DESCRIPTION: Ltr not sized 5-9-75....trans the follow:	ENCLOSURES: Amdt to OL/Change to Tech Specs: Consisting of revisions to the tech specs with regard to the regulating control rod positions.... (40 cys encl rec'd)
PLANT NAME: Oconee 1-3

Re: Oconee Nuclear Station
Docket Nos. 50-269, -270, -287

The proposed revisions apply to Specifications 3.1.3.5, 3.5.2.3, and 3.5.2.5. The revision to Specification 3.1.3.5 incorporates an additional restriction on the regulating control rod positions prior to criticality to assure that the ejected rod worth does not exceed the 1.0% $\Delta k/k$ limit at hot zero power. The revision to Specification 3.5.2.3 deletes the specification on inserted control rod worths but at the same time specifies the manner in which the inserted control rod worths are to be maintained within acceptable limits. Finally, the revision to Specification 3.5.2.5 modifies the rod withdrawal limits for Oconee Units 2 and 3 after the control rod interchange.

UNIT 2
OCONEE NUCLEAR STATION
Figure 3.5.2-1B1

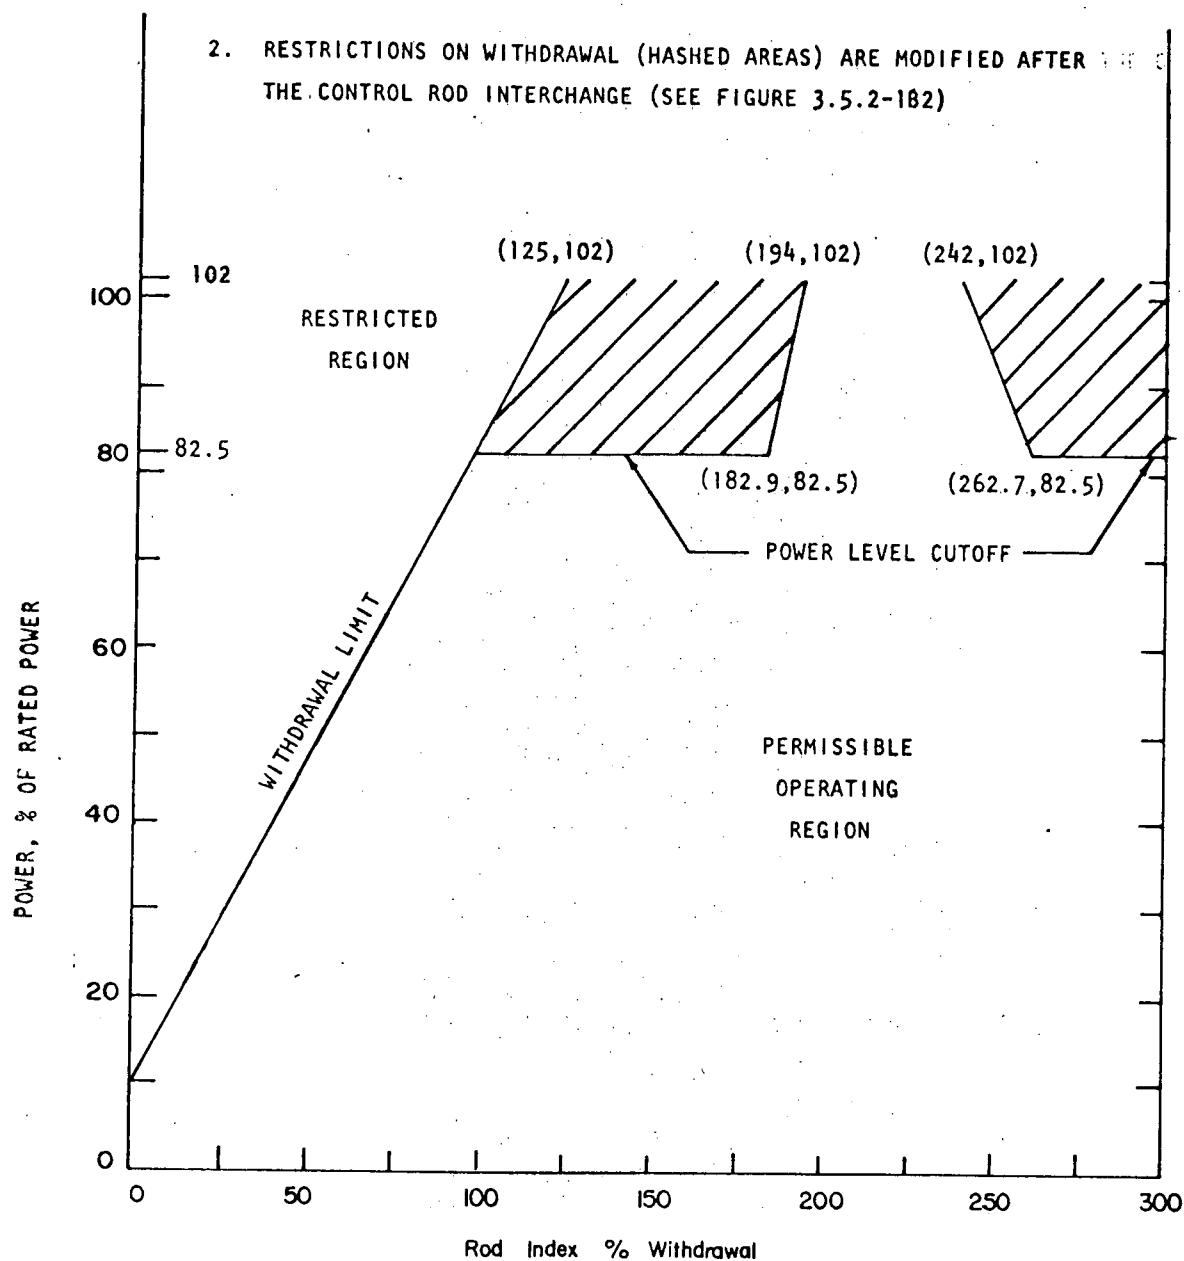
for the rod withdrawal limits specified. (An analysis of the Oconee 1, Cycle 2 ejected rod worth has been submitted to the NRC in a letter of April 14, 1975, from Mr. A. C. Thies to Mr. Norman C. Moseley, with a copy sent to Mr. Angelo Giambusso.) For Oconee 2 and 3, revised rod withdrawal limits have been proposed since the hot zero power ejected rod worths after the control rod interchange have been predicted to exceed $1\% \Delta k/k$ for certain control positions allowed by the present Specification 3.5.2.5.

2. RESTRICTIONS ON WITHDRAWAL (HASHED AREAS) ARE MODIFIED AFTER THE CONTROL ROD INTERCHANGE (SEE FIGURE 3.5.2-1B2)

UNIT 2
OCONEE NUCLEAR STATION
Figure 3.5.2-1B2

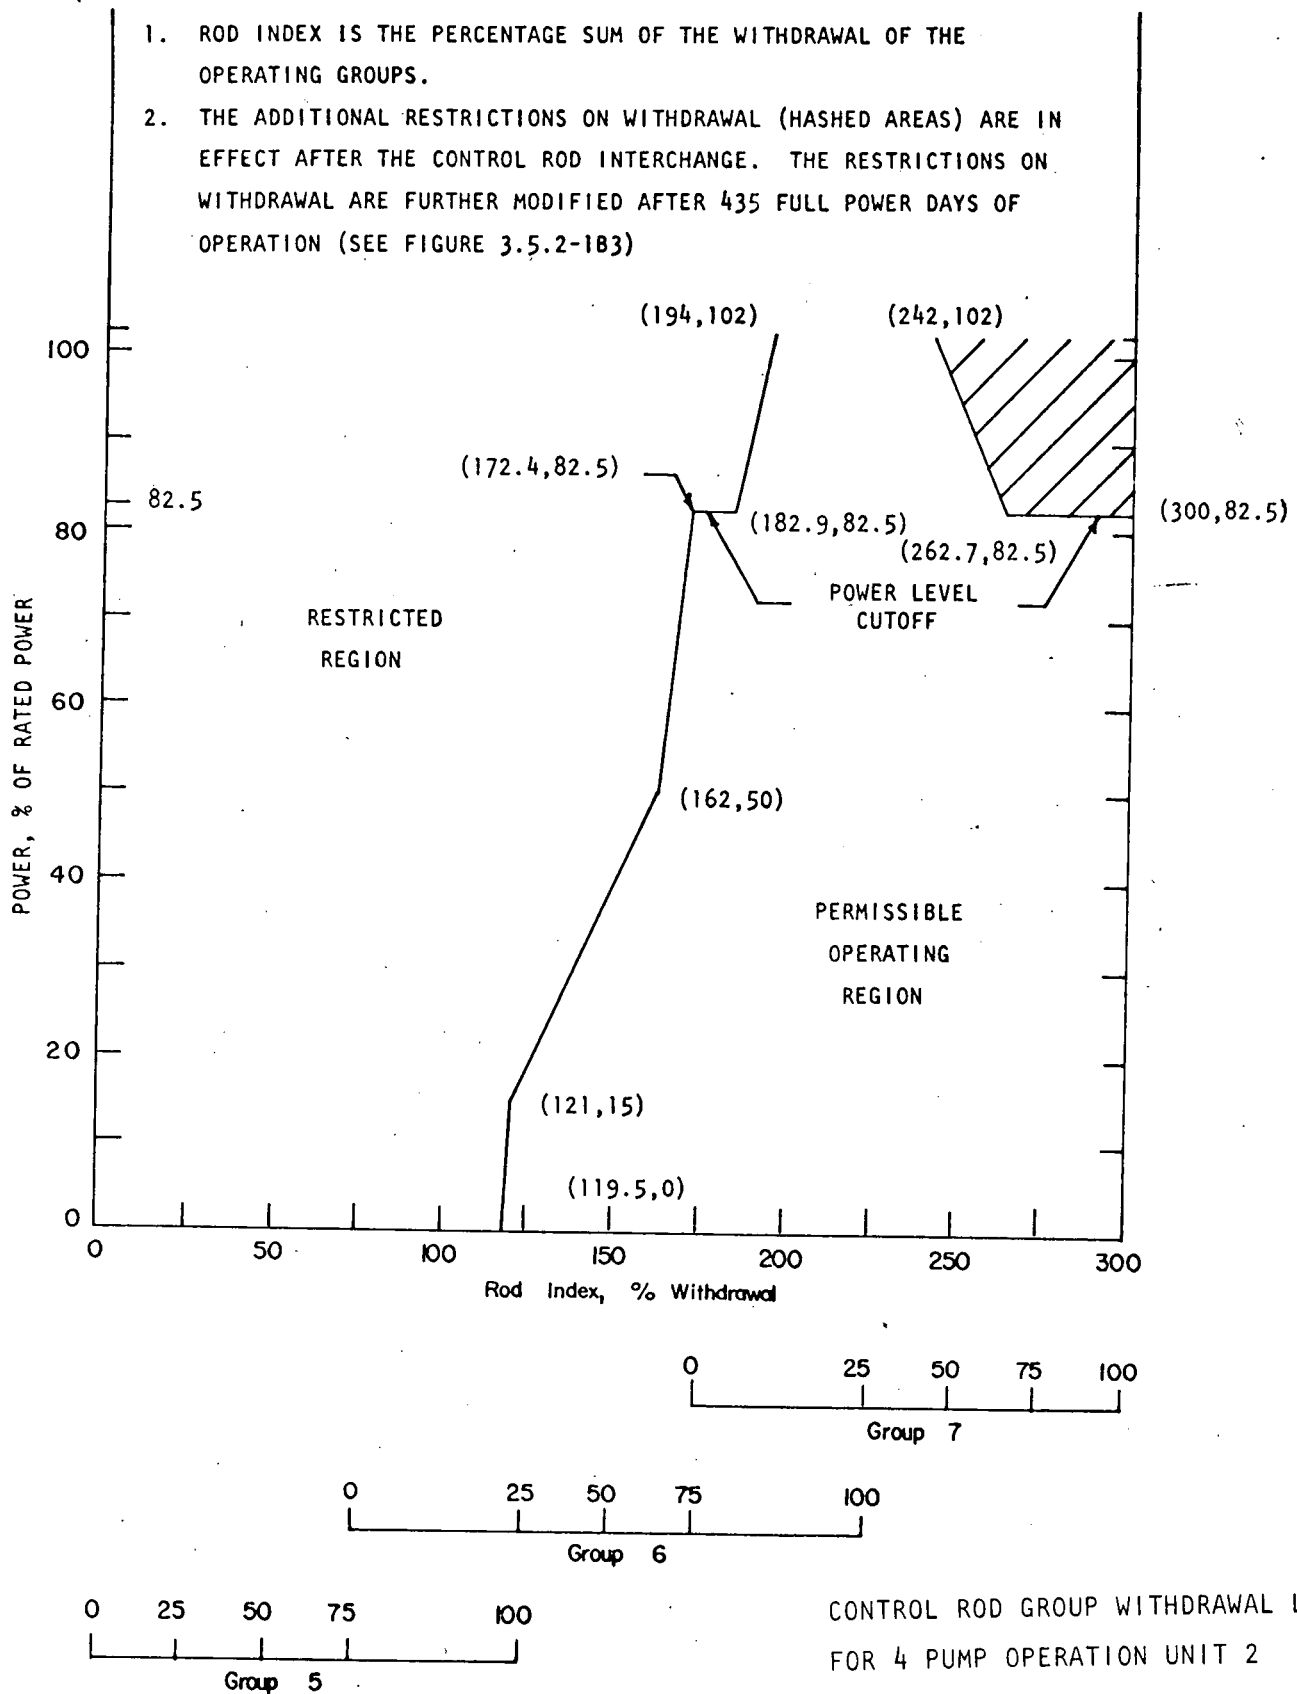
1. ROD INDEX IS THE PERCENTAGE SUM OF THE WITHDRAWAL OF THE OPERATING GROUPS.
2. THE ADDITIONAL RESTRICTIONS ON WITHDRAWAL (HASHED AREAS) ARE IN EFFECT AFTER THE CONTROL ROD INTERCHANGE. THE RESTRICTIONS ON WITHDRAWAL ARE FURTHER MODIFIED AFTER 435 FULL POWER DAYS OF OPERATION (SEE FIGURE 3.5.2-1B3)

Figure 3.5.2-1B3

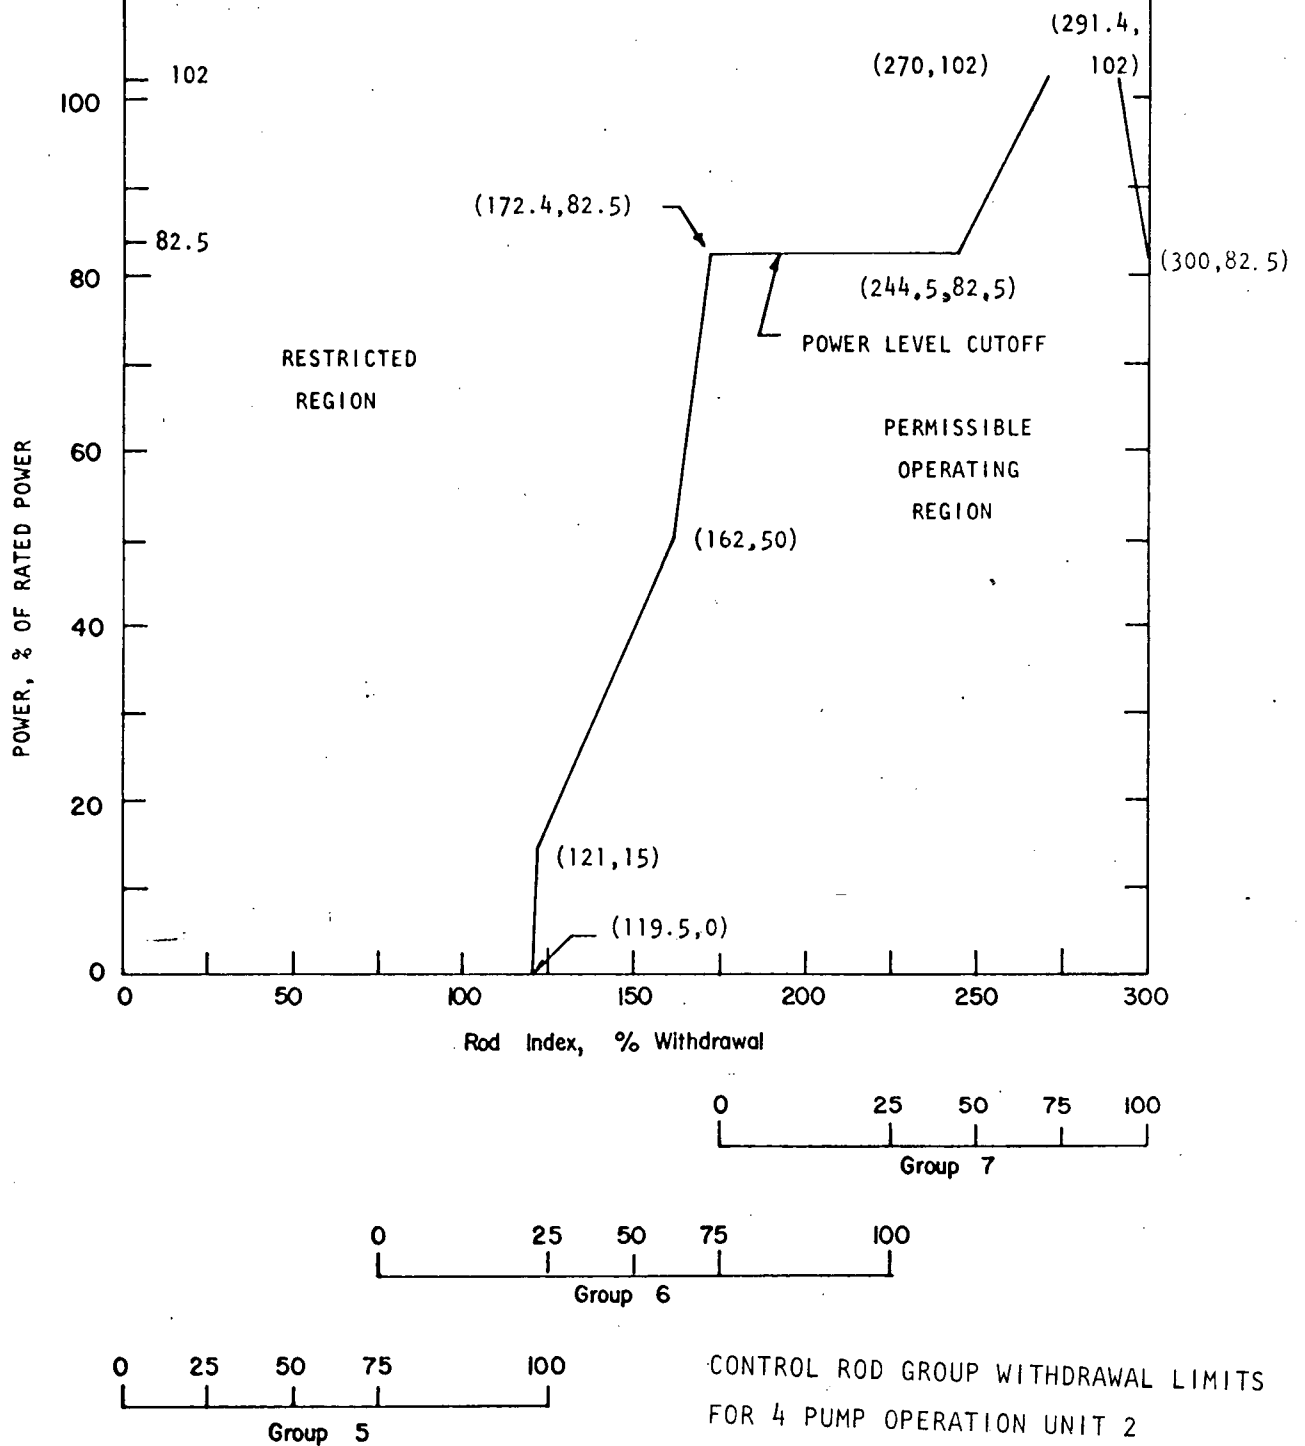
1. ROD INDEX IS THE PERCENTAGE SUM OF THE WITHDRAWAL OF THE OPERATING GROUPS.
2. THE ADDITIONAL RESTRICTIONS ON WITHDRAWAL ARE IN EFFECT AFTER 435 FULL POWER DAYS OF OPERATION.

UNIT 3
OCONEE NUCLEAR STATION
Figure 3.5.2-1C2

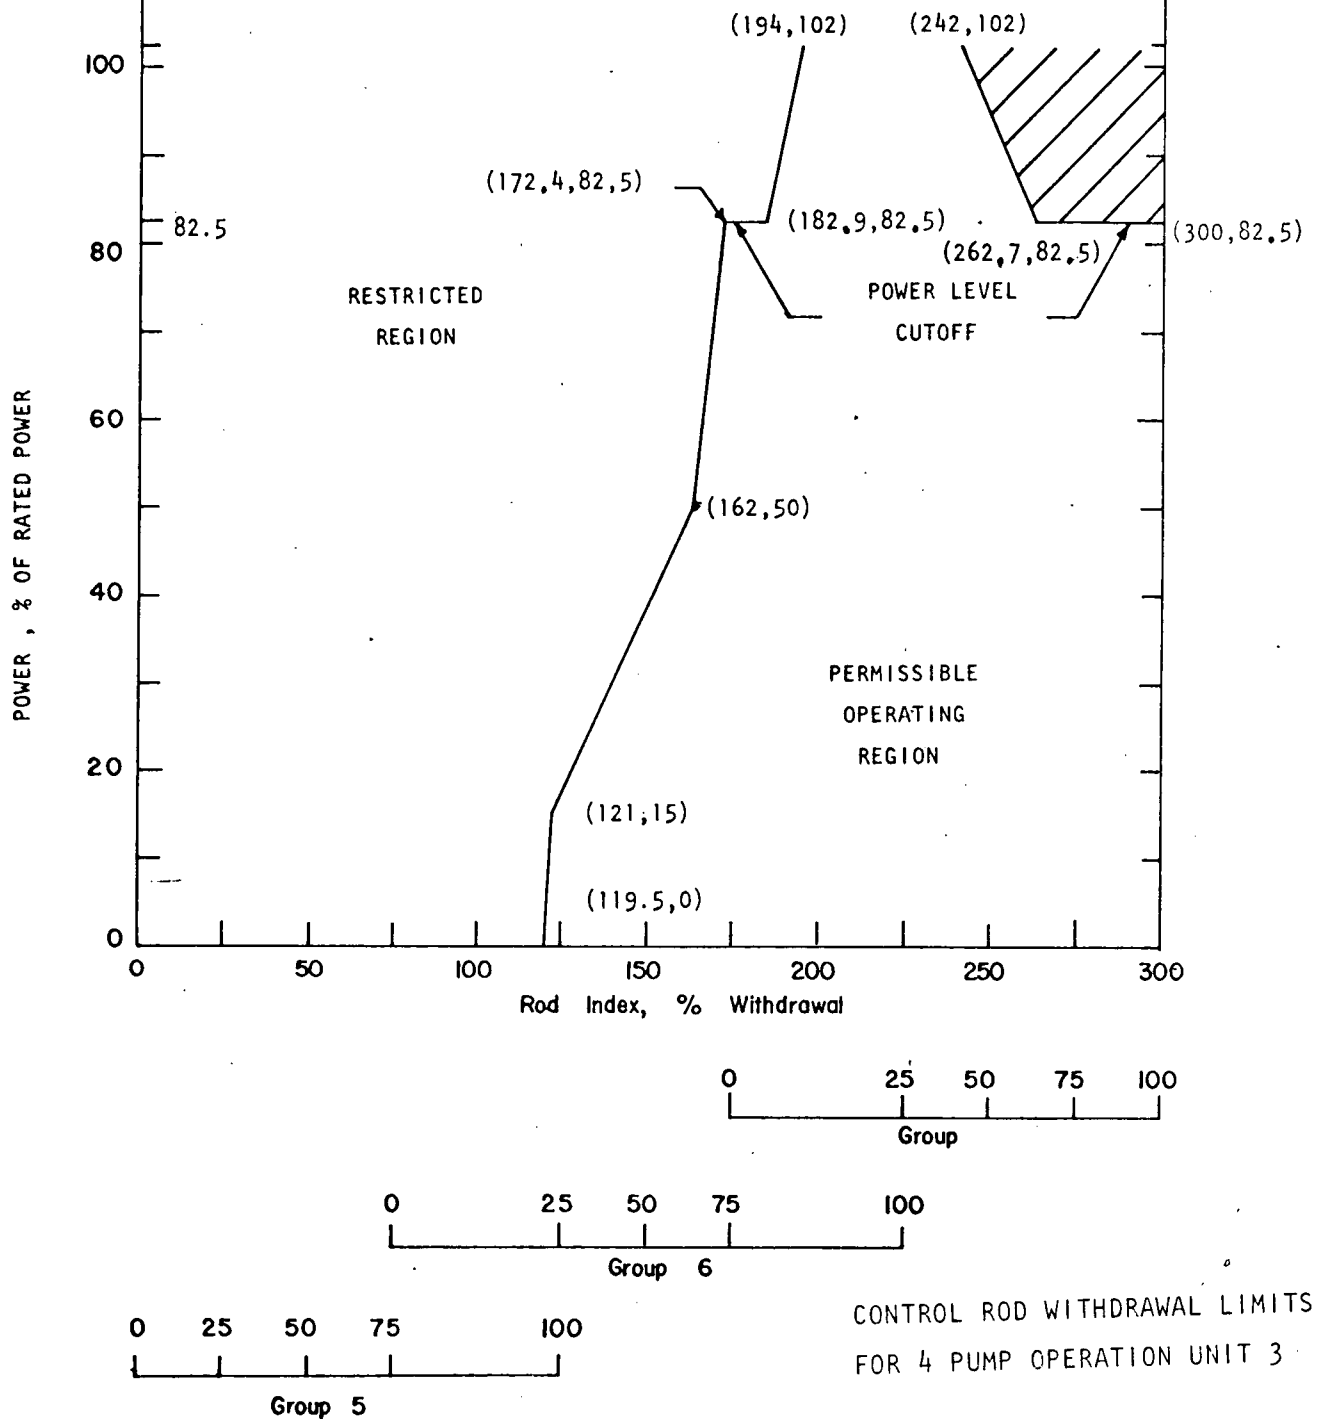
1. ROD INDEX IS THE PERCENTAGE SUM OF THE WITHDRAWAL OF THE OPERATING GROUPS.
2. THE ADDITIONAL RESTRICTIONS ON WITHDRAWAL (HASHED AREAS) ARE IN EFFECT AFTER THE CONTROL ROD INTERCHANGE. THE RESTRICTIONS ON WITHDRAWAL ARE FURTHER MODIFIED AFTER 435 FULL POWER DAYS OF OPERATION (SEE FIGURE 3.5.2-1C3)

UNIT 3
OCONEE NUCLEAR STATION
Figure 3.5.2-1C3

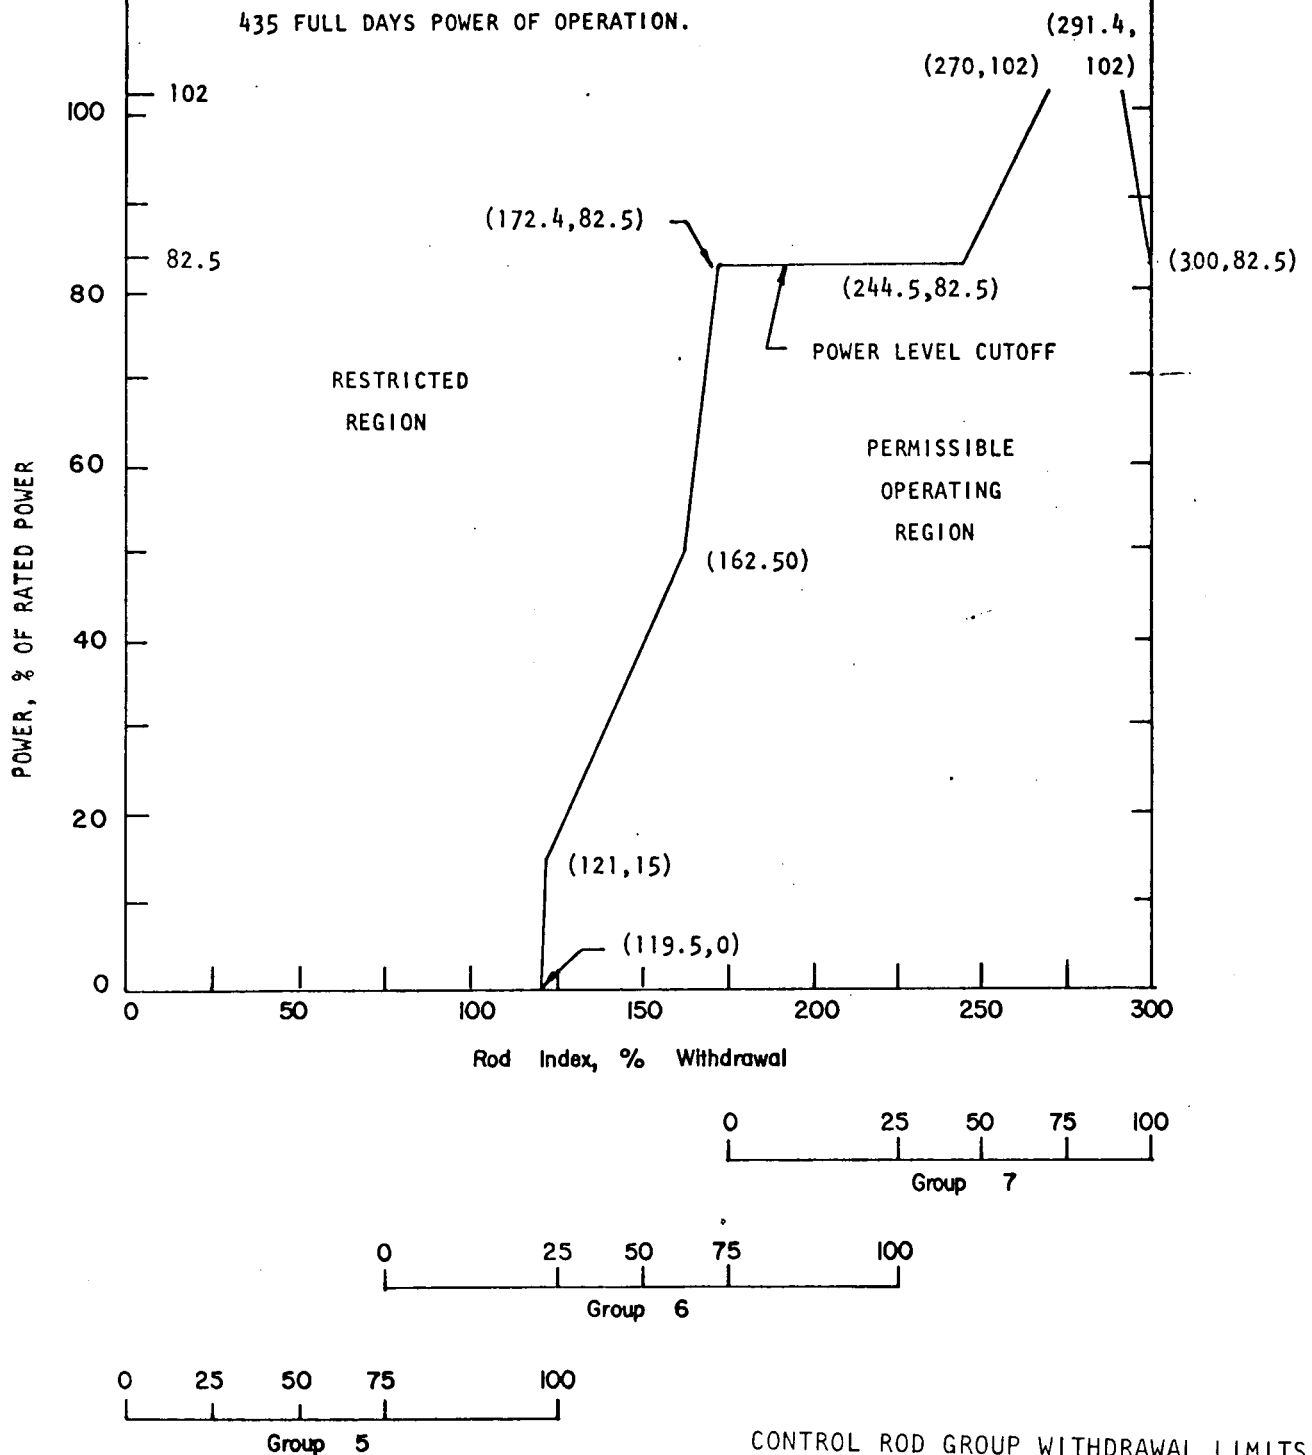
1. ROD INDEX IS THE PERCENTAGE SUM OF THE WITHDRAWAL OF THE OPERATING GROUPS.
2. THE ADDITIONAL RESTRICTIONS ON WITHDRAWAL ARE IN EFFECT AFTER 435 FULL DAYS POWER OF OPERATION.
